SERVICE BULLETIN

Inspection, Check and Replacement of Hook
Assembly P/Ns 505960-401 and 502737-459

All Aircraft Types Affected

SB505960-01, Issue: 6
Page: 1 of 13
Date: 07-Nov-2019

Figure 2 – Hook Assembly With Exposed Springs

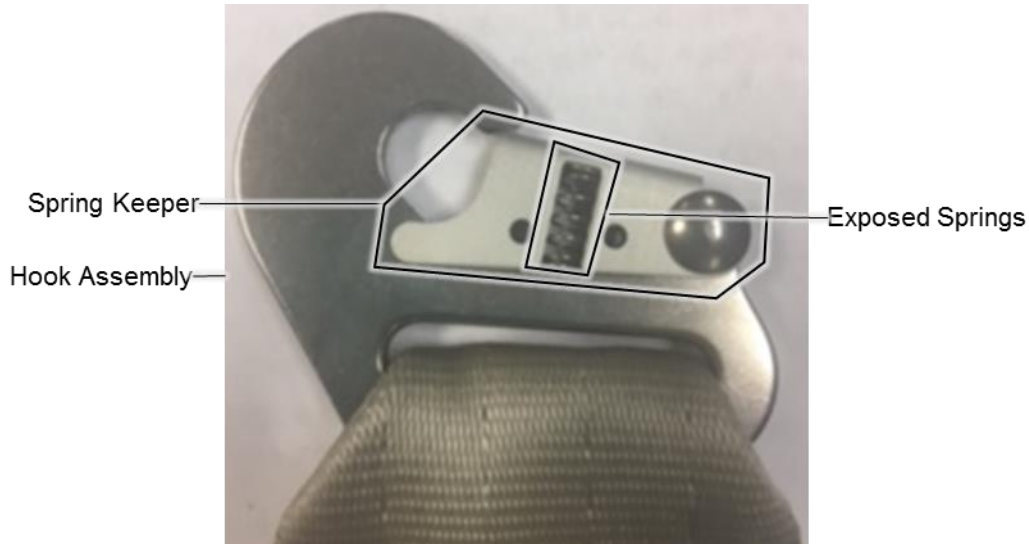
Step 2. Determine if the hook assembly has exposed springs.

Step a. Find the hook assembly (Figure 1 and Figure 2) on the connector half and the buckle half.

Step i. If the hook assembly on the connector half or the buckle half does not have exposed springs (Figure 1) you are done with this service bulletin.

Step ii. If the hook assembly has exposed springs (Figure 2) proceed with this service bulletin.

Restraints without exposed springs (Figure 1) weigh 6 grams more than restraints with exposed springs (Figure 2).

Figure 3 – Damaged Hook Assembly

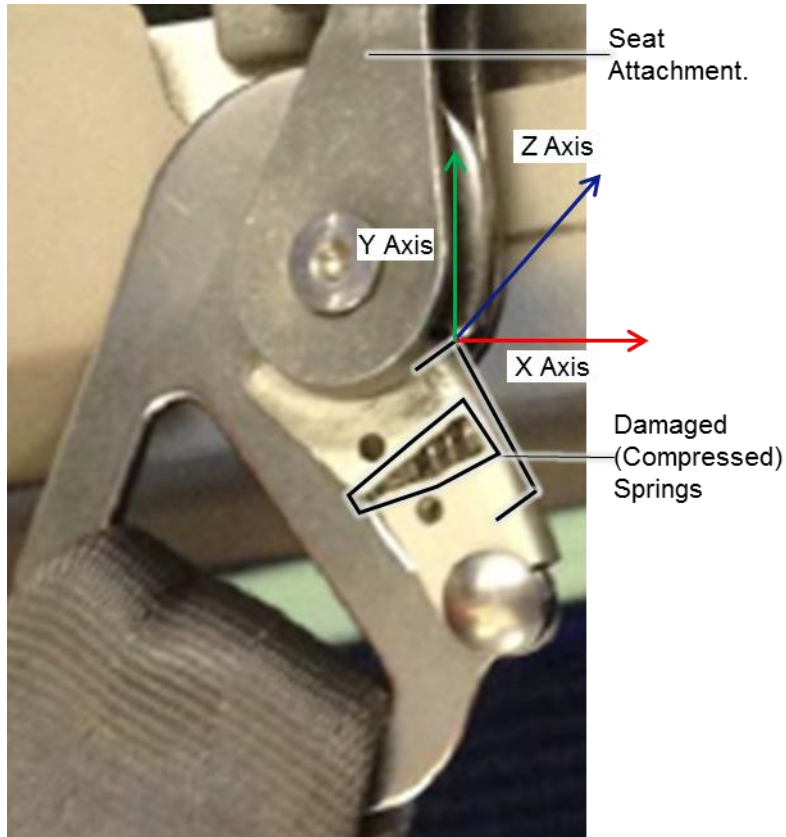
Step 2. Visually examine the hook assembly for damage (e.g., compressed springs, bends, rotation or deformation of the bridge along the X axis, Y axis or Z axis) that would restrict movement or function (Figure 3 and Figure 4).

Step a. If there is no evidence of damage the visual inspection is complete. Perform a functional check following the procedure in section 3.3.

Step b. If there is evidence of damage a functional check is not required.

Step i. Return the restraint to AmSafe by following the instructions in section 2.1 and by following the shipping and handling instructions in the ICA or CMM.

Step ii. Upon receipt of a new restraint from AmSafe, install the new restraint following the instructions in the ICA or CMM.

Figure 5 – Spring Keeper and Closed Loop

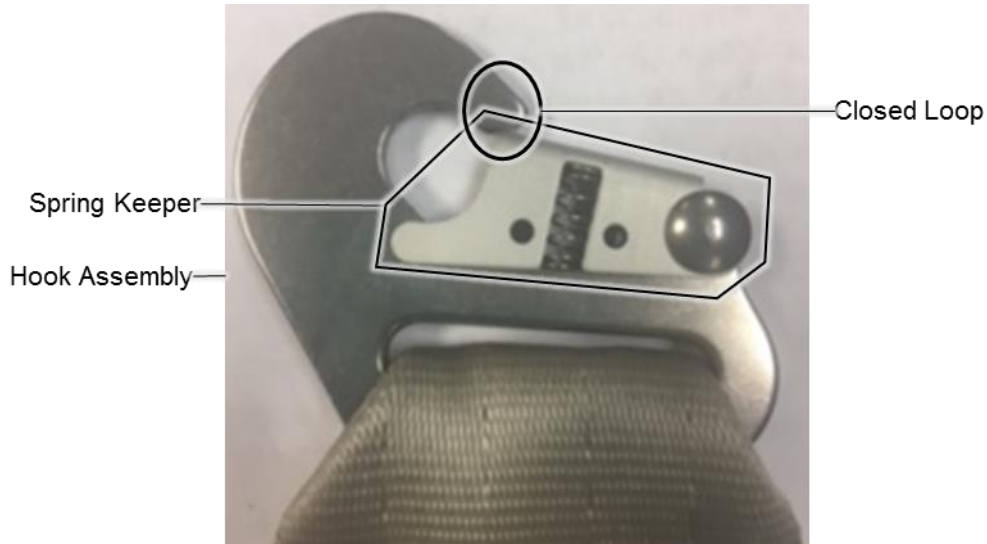
Step b. The spring keeper should return to a closed position. The closed position is achieved when the spring is firmly engaged/pressed and the keeper is against the hook, creating “closed loop” (Figure 5). There should be no deformation or damage preventing the spring keeper from returning to a closed position.

- Step c. If the spring keeper easily compresses and releases and returns to the closed position the functional check is complete.
- Step d. If the spring keeper does not easily compress and release, or the spring keeper does not return to a closed position, return the restraint to AmSafe.
- Step i. Return the restraint to AmSafe by following the instructions in section 2.1 and by following the shipping and handling instructions in the ICA or CMM.
- Step ii. Upon receipt of a new restraint from AmSafe, install the new restraint following the instructions in the ICA or CMM.
